## **DEVELOPMENT REVIEW COMMITTEE (DRC) COMMENT REPORT**

**PROJECT NAME:** Lauderdale Yacht Club

**CASE NUMBER:** R18056

**REQUEST:** Site Plan Level III Review: Conditional Use;  
Yacht Club and Associated Parking Reduction

Existing Stormwater Asset Map possibly affected by the Proposed Development

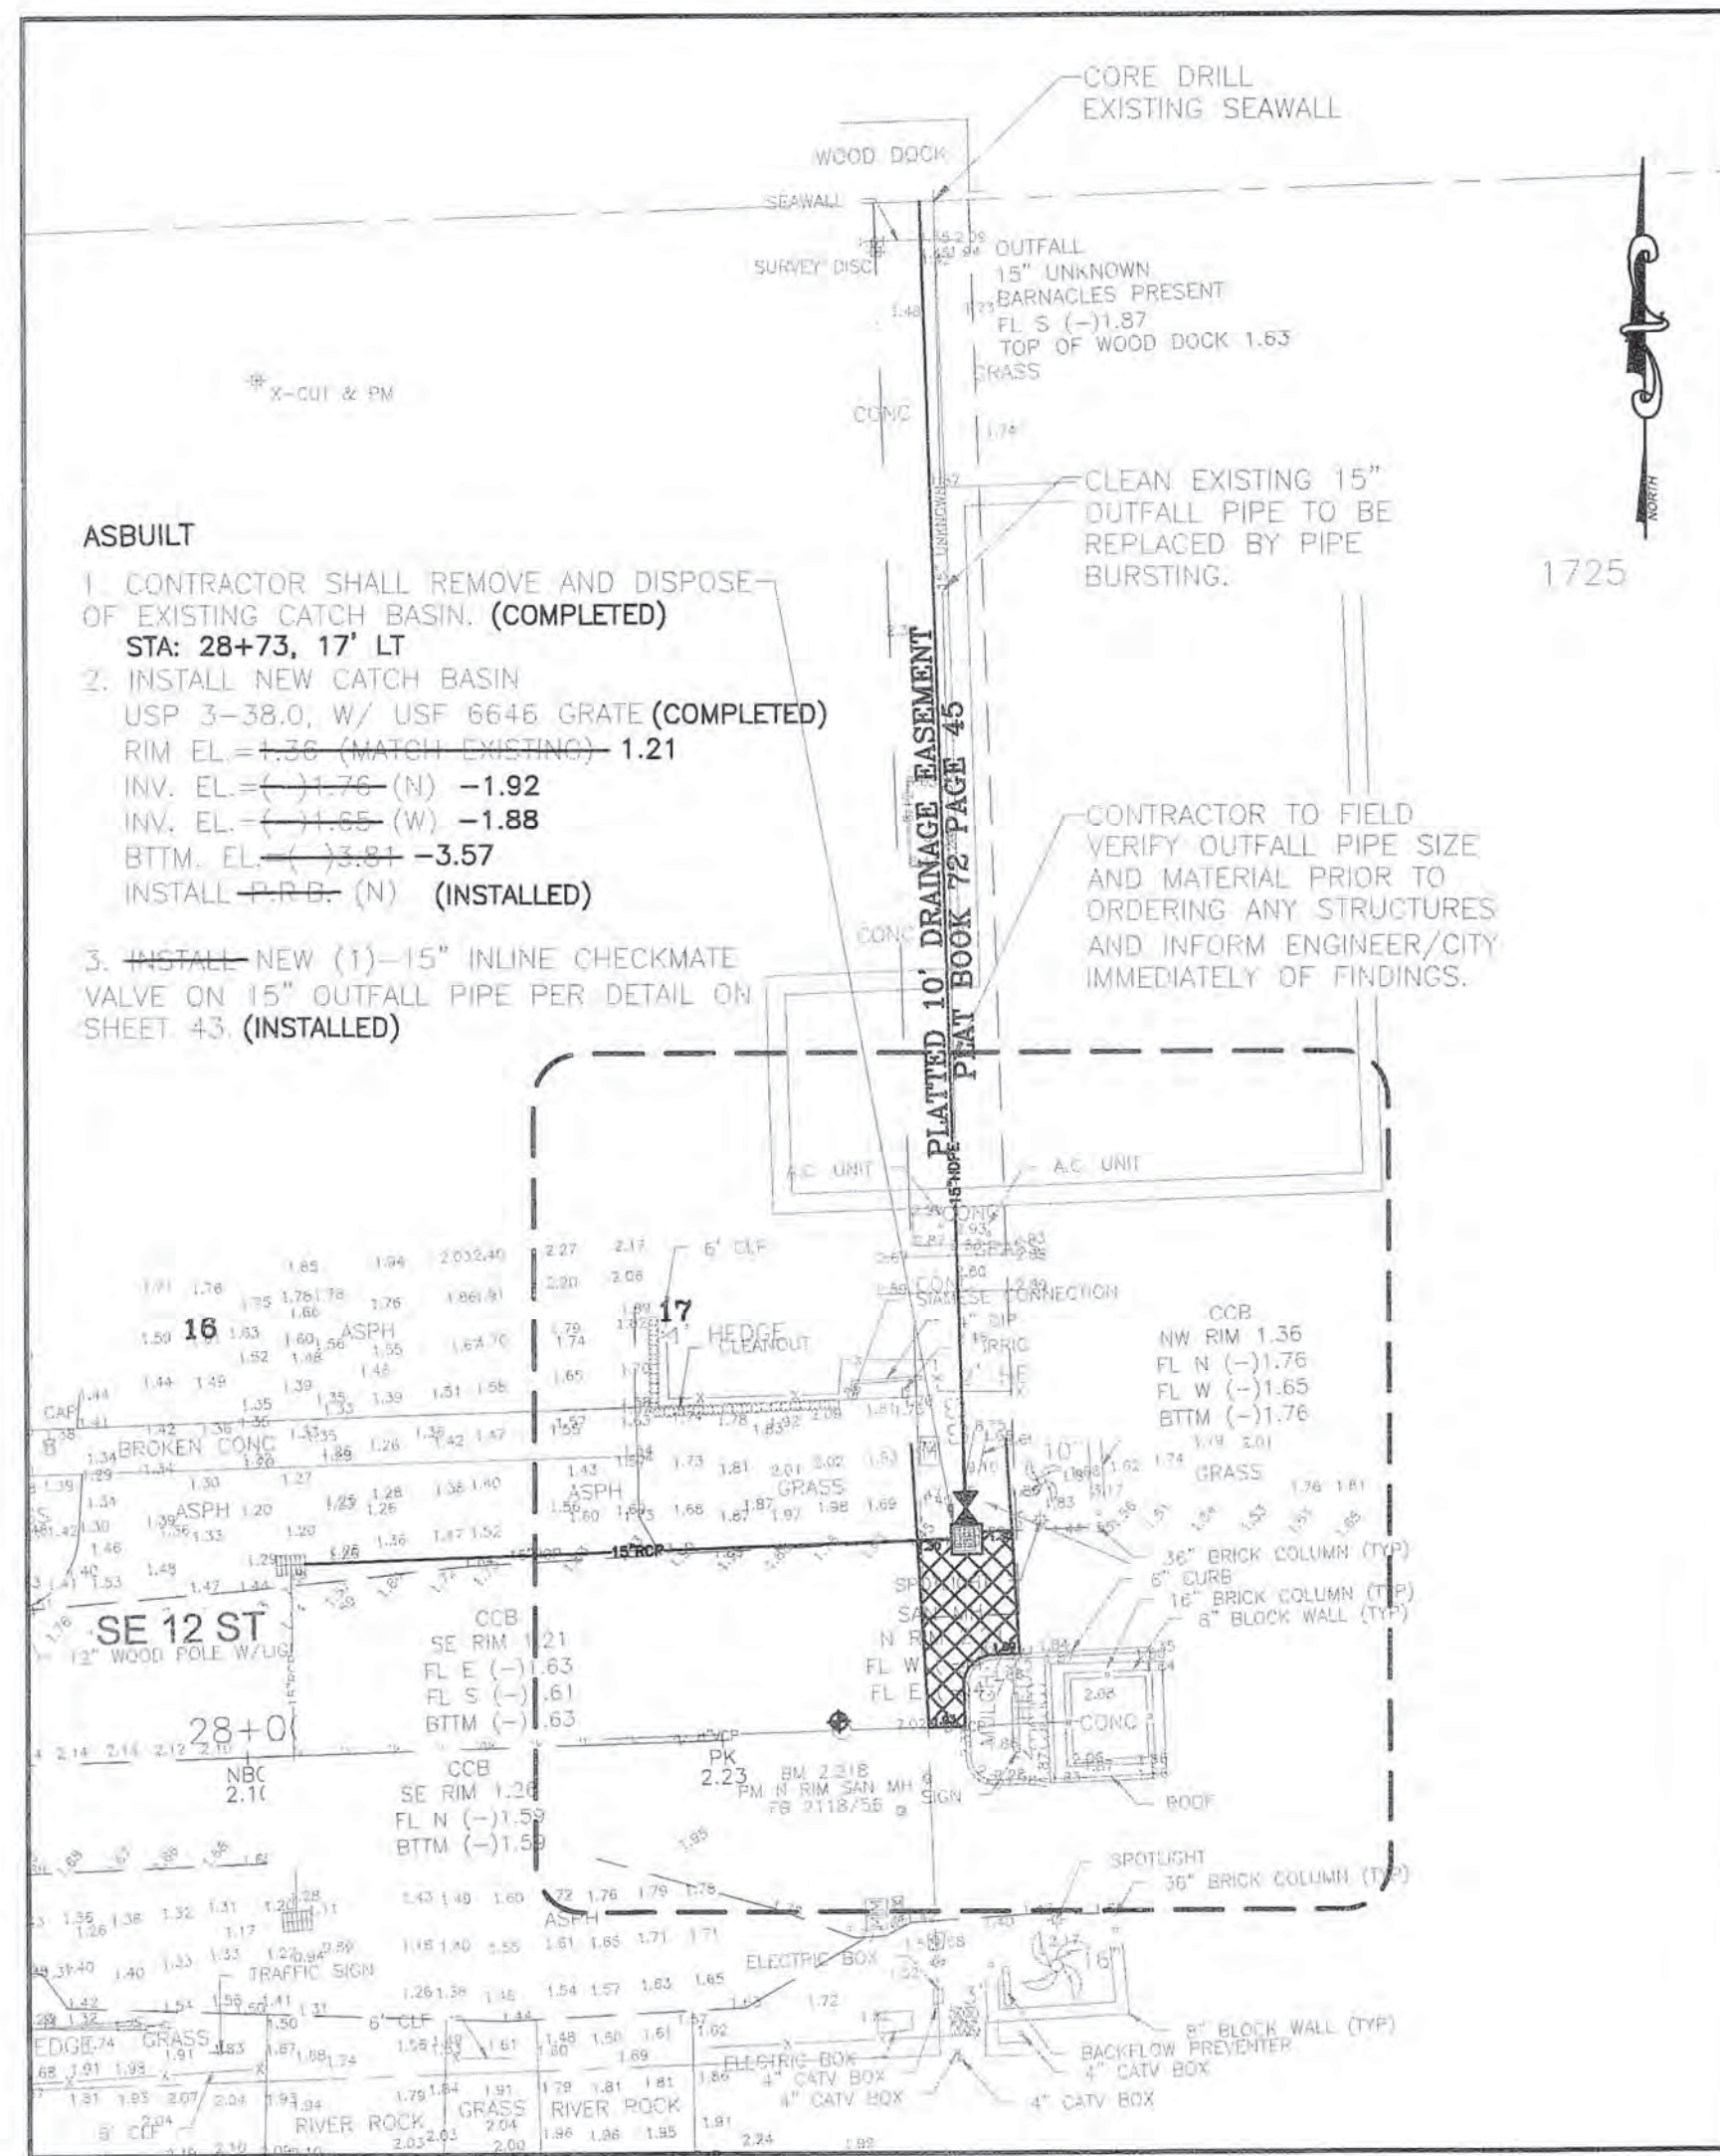
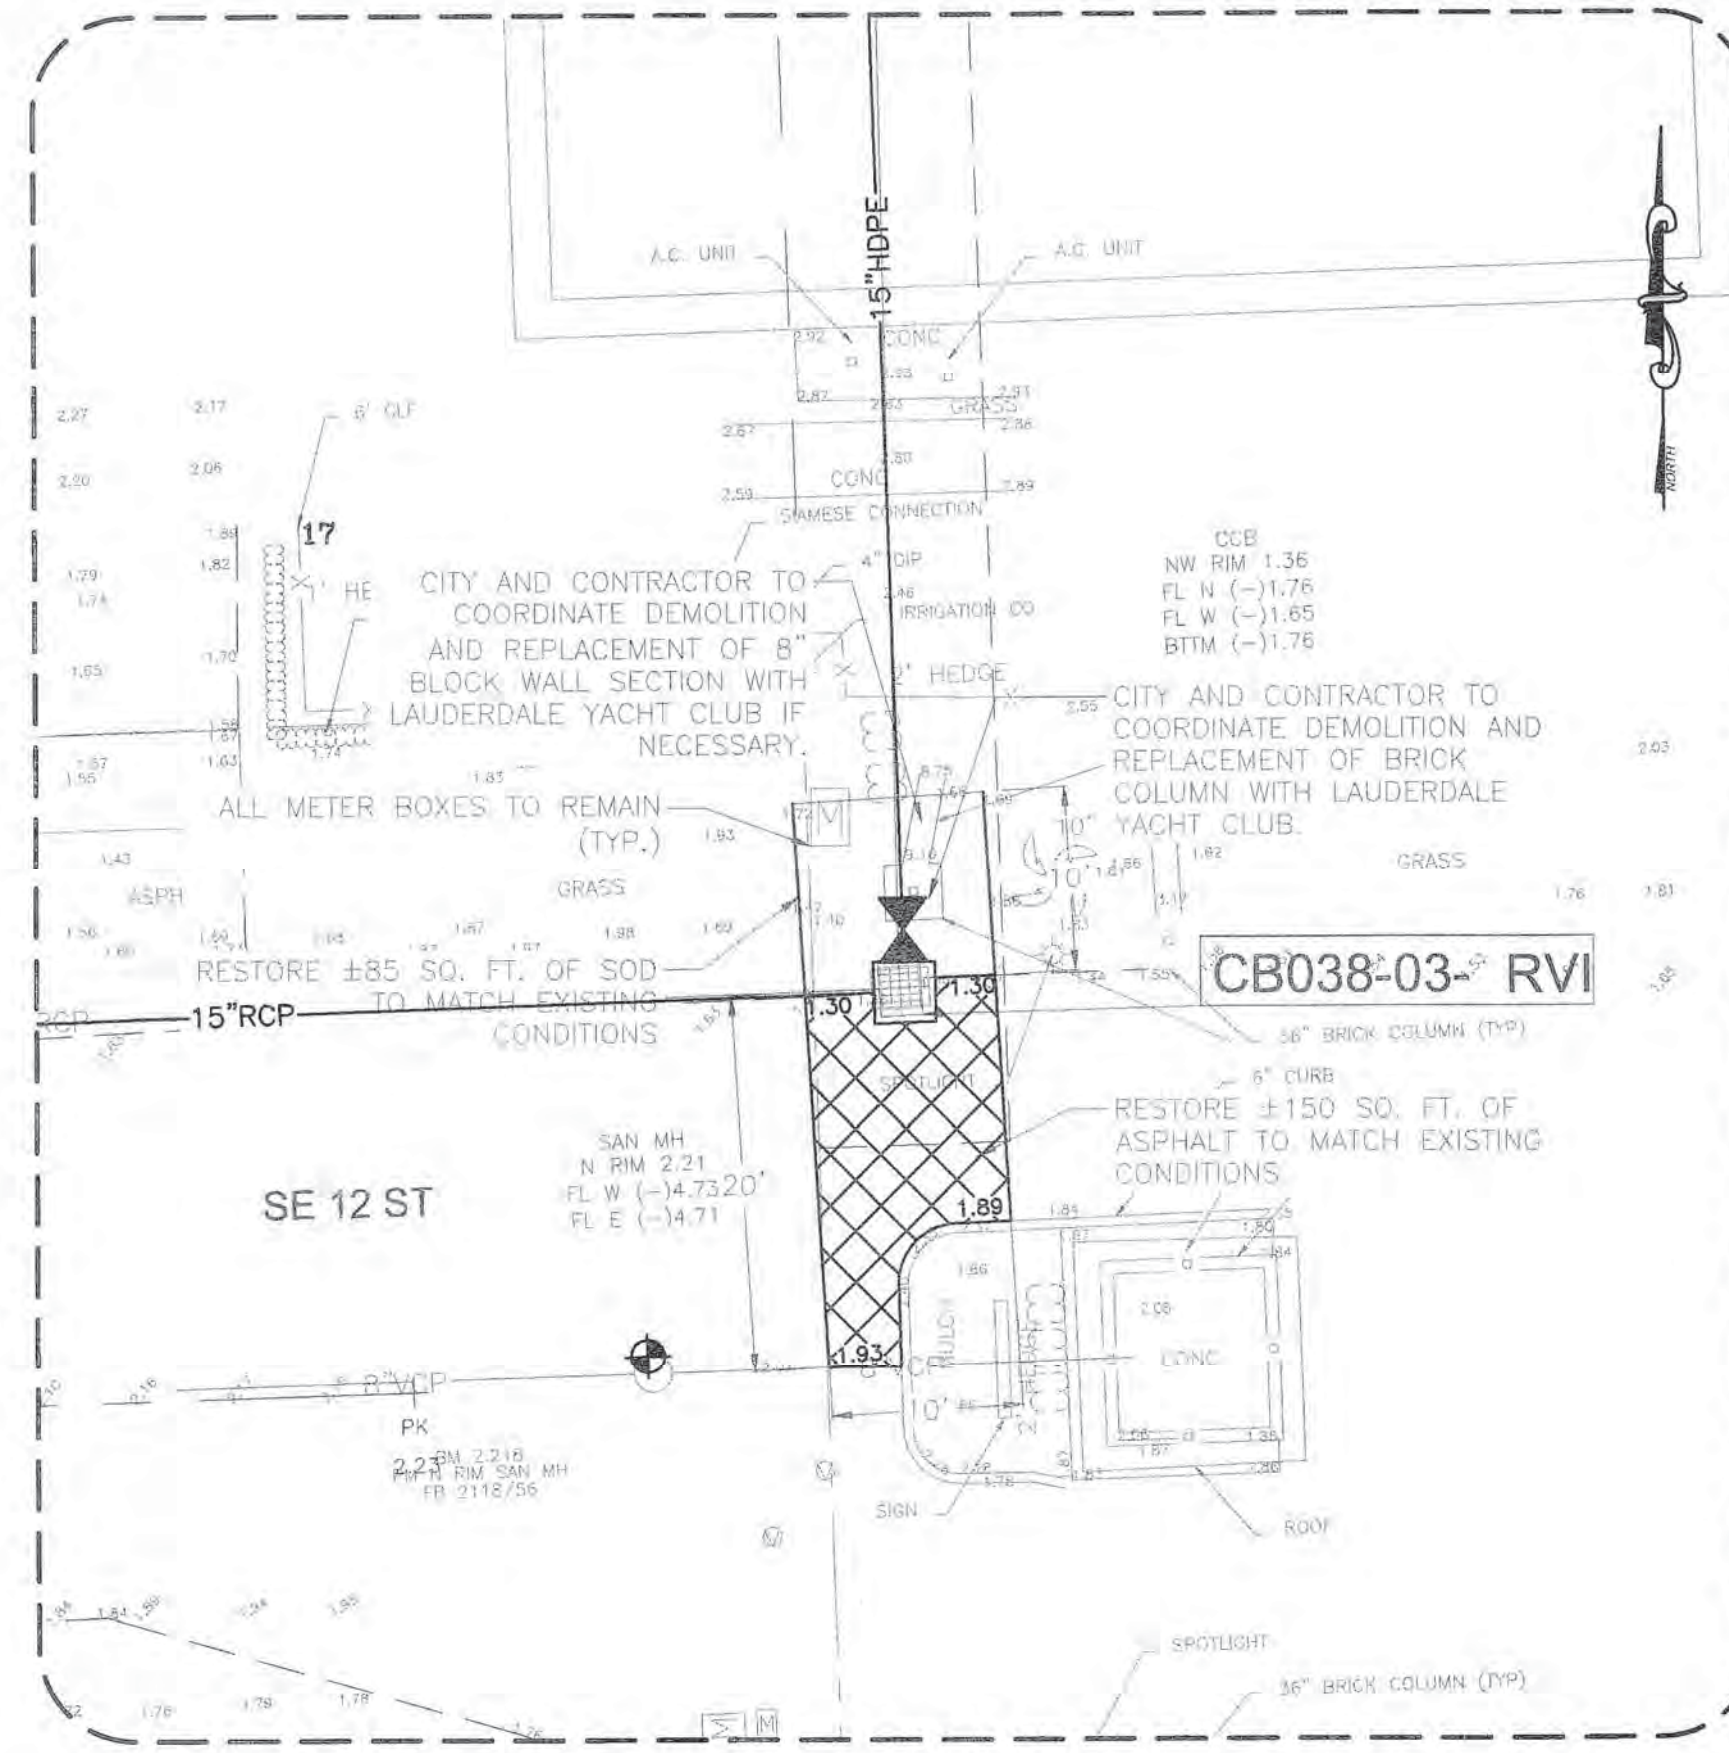
The City owns and maintains stormwater infrastructure adjacent to the proposed development as shown with green line work in the map provided at the end of this report and asbuilt plan. The following comments pertain to possible impacts of the proposed development and/or construction activities to the existing condition of the City's stormwater assets. The applicant shall provide an itemized response letter addressing the following comments:

3. There is an existing 15" City stormwater drainage outfall and a drainage catch basin on SE 12 St at the north side of the guardhouse. The existing building(s) that are currently over the drainage pipe that are proposed to be renovated require the relocation of the drainage easement and the public drainage outfall pipe. Engineer of record shall proposed City DSD Engineering staff possible solutions to rectify the conflict(s), so Public Works Stormwater Operations and Engineering divisions can review.

- a) Contractor shall provide CCTV videotapes to City STW OPS of the existing stormwater system to the limits shown with green line work in the storm map provided at the end of this report in order to document the PRE and POST construction conditions of the City's storm system.
- b) Contractor shall provide the PRE construction CCTV to City STW OPS when applying for a demolition permit at the City's building department.
